REPORT TO THE BELOIT LANDMARKS COMMISSION

Meeting Date: April 17, 2012 Agenda Item: 6 File Number: COA-2012-06

Applicant: Michael Brady, on behalf of Owner: Beloit College Location: 700 College Street

Michael Brady, on behalf of Beloit College, has submitted an application for a Certificate of Appropriateness (COA) to add two accessible ramps to the portico entryway of Middle College, to redesign the portico steps and landing of Middle College, and to redesign the plaza area and widen walking paths along the plaza area surrounding Middle College, which is located at 700 College Street. The subject property is located in the College Park Historic District, and Section 32.06 of the Historic Preservation Ordinance grants the Landmarks Commission the authority to issue a COA prior to the alteration of structures within a Historic District.

Middle College Portico and Plaza

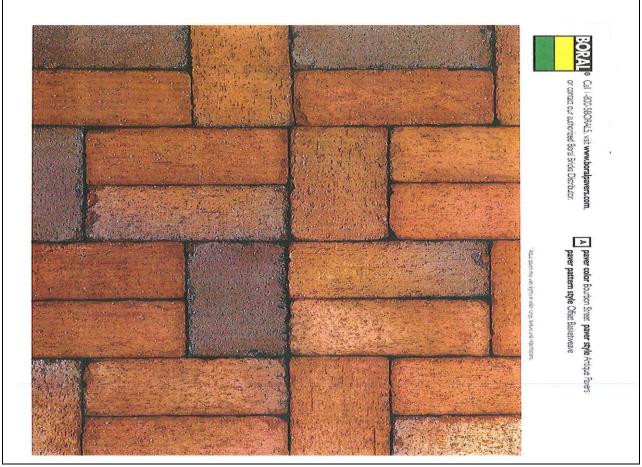
- Several photographs of Middle College are attached to this report.
- The existing flight of stairs on all sides of the portico foundation will be removed and redesigned to accommodate two accessible ramps that will be located on the left and right sides of the portico.

- A new flight of stairs will be established at the front entryway of the portico. The new flight of stairs will project roughly 14 feet into the plaza area and will be curbed and composed of concrete. The treads will be 12 inches and the risers will be 6 inches. The landing of the portico will be paved with brick pavers to match the composition of existing plaza brick pavers (see-attached photo for description).

Handrails of Eaton Chapel

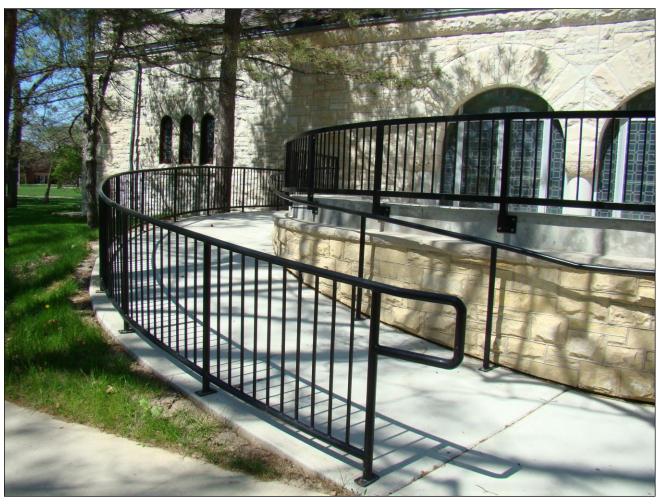
- The two accessible ramps will be composed of concrete and faced with limestone that is similar in appearance to the limestone found on the foundation of Middle College (see-attached photo). Concrete ledges will be used to cap the limestone wall and support steel tube handrails. The steel tube handrails will be black in color and look similar to the handrails found on Eaton Chapel's accessible ramp (see-attached photo). The ramps will roughly be 2.5 feet above grade. The handrails will be 3 feet in height. The limestone-faced ramps will be screened from view by plantings listed in the landscape plan. The pathways of the ramps will be concrete with a broom finish.
